Report Appendix L Addendum: Hydrologic Modeling of the Santa Clara River with U.S. EPA Hydrologic Simulation Program – FORTRAN (HSPF) December, 2009

Feasibility Study

February, 2011

Figure1-1- Old and Revised HSPF Model Boundaries

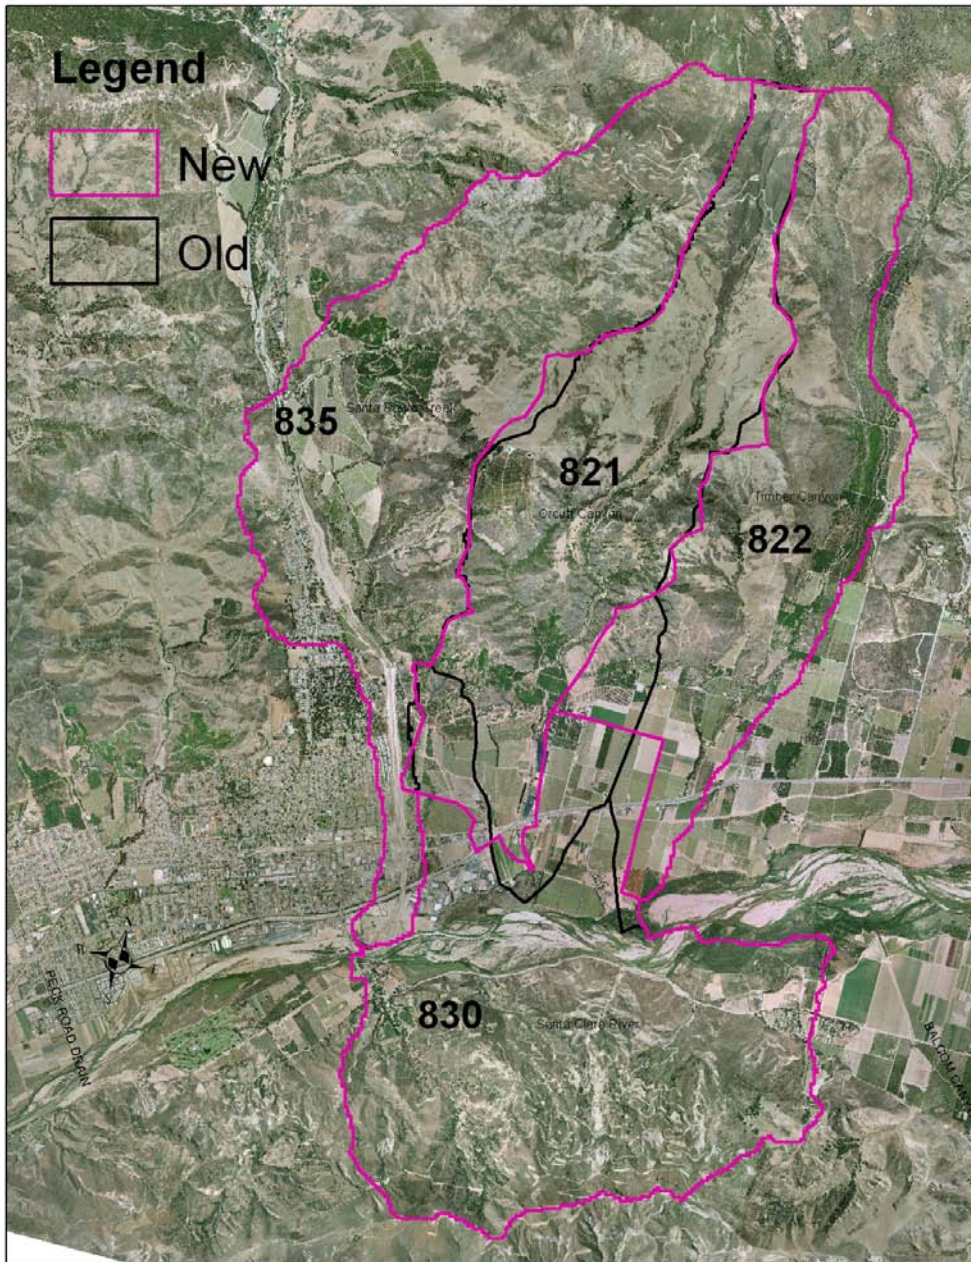
As a result of the Jensen study, it is necessary to revise the HSPF model boundary for Orcutt Creek in the HSPF design storm model. The revisions to subarea 821 representing Orcutt in the HSPF model also affected subarea 822 (Timber Canyon), subarea 835 (lower Santa Paula Creek), and subarea 830 (mainstem of the Santa Clara River) as shown in Figure 1-1. The revised land uses based on the new boundaries were calculated following the same steps and using the same files as in the Aqua Terra (2009) report and the .uci file controlling the HSPF simulation was revised accordingly. The model was then run and the rainfall factor for subarea 821 was adjusted to match the VCRat result so that the two models would provide consistent results.

The numerous subareas used by Jensen in their modified rational method model of the watershed were merged into one watershed boundary. This new boundary was used to revise the boundaries of the HSPF model as shown in Figure 1-1.
